SITE INSPECTION REPORT

Indian Wells Villas

Subject: Site Inspection Report

Indian Wells Villas
74-800 Village Center Drive
Indian Wells CA 92210
Partner Project No. 24-441517

2. Solar Modules

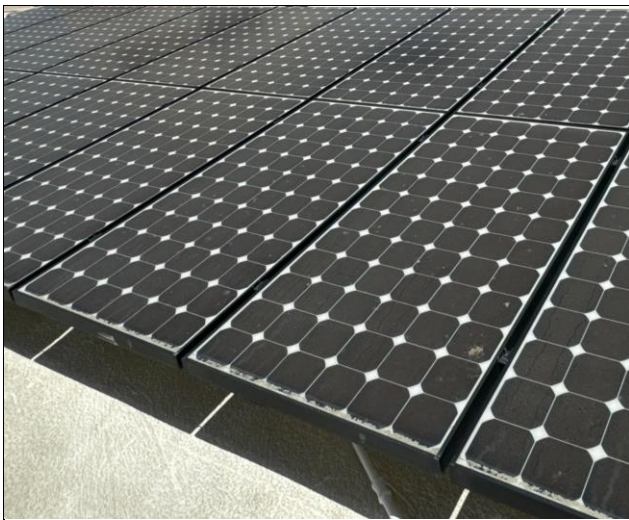
- a) Soiling observed on solar modules.
- b) Connections were missing torque marks.
- c) Grounding wire was observed to be loose and not connected.
- d) DC wires and module labels were painted.
- e) PV wires need to be properly managed off the roof.
